Subject: Pre-Application Summary Notes for Beaverton High School (PA2022-0022)

# PRE-APPLICATION CONFERENCE MEETING SUMMARY NOTES

## Prepared for Beaverton High School PA2022-0022

**Pre-Application Conference Number:** PA2022-0022

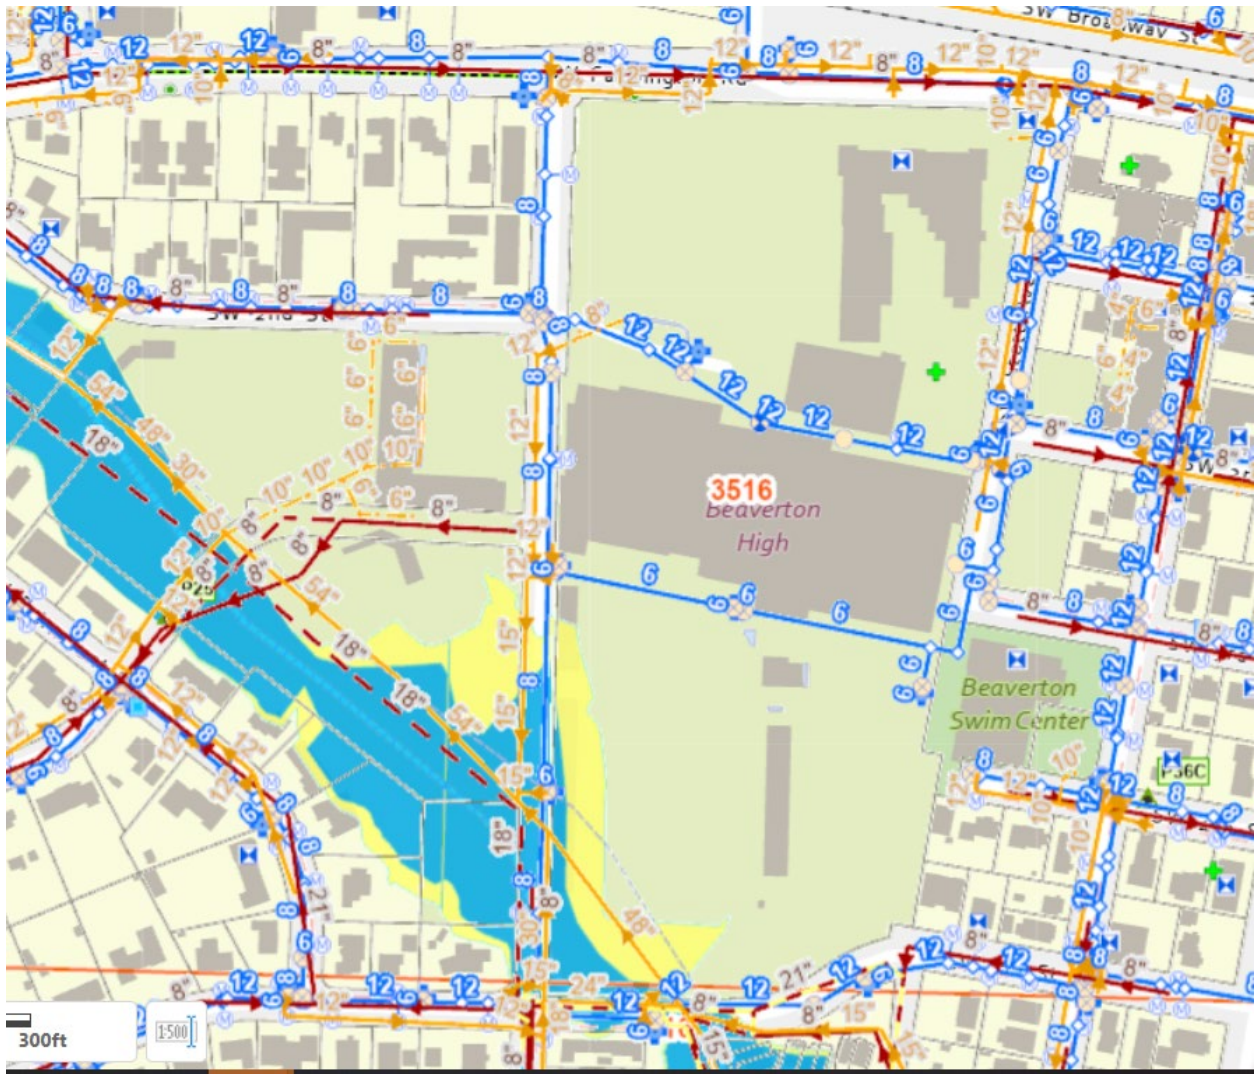
City of Beaverton sanitary sewer and storm drainage are in the vicinity of this project and can serve this site. There are 12" public storm along SW Farmington, SW Stott, and SW Erickson. There is a 54" public storm line that crosses the west sports field. An 8" public sanitary line also crosses this field. There are 8" public sanitary lines along SW Stott, SW 1<sup>st</sup>, SW 2<sup>nd</sup>, and SW 3<sup>rd</sup> St.

City of Beaverton is the water provider for this site. There are 12" and 6" public water lines that cross through the site from east to west. There is also an 8" water line along SW Erickson and a 6" water line along SW Stott Ave. There is a 12" line along SW 1<sup>st</sup> St. and 8" lines along SW 2<sup>nd</sup> and SW 3<sup>rd</sup> St. A Service Provider Letter (SPL) will be required for new connections to the water system and/or changes in water meter size, see next page for contact information. Any proposed relocations of public water lines will need to be coordinated with Public Works engineers and operations.
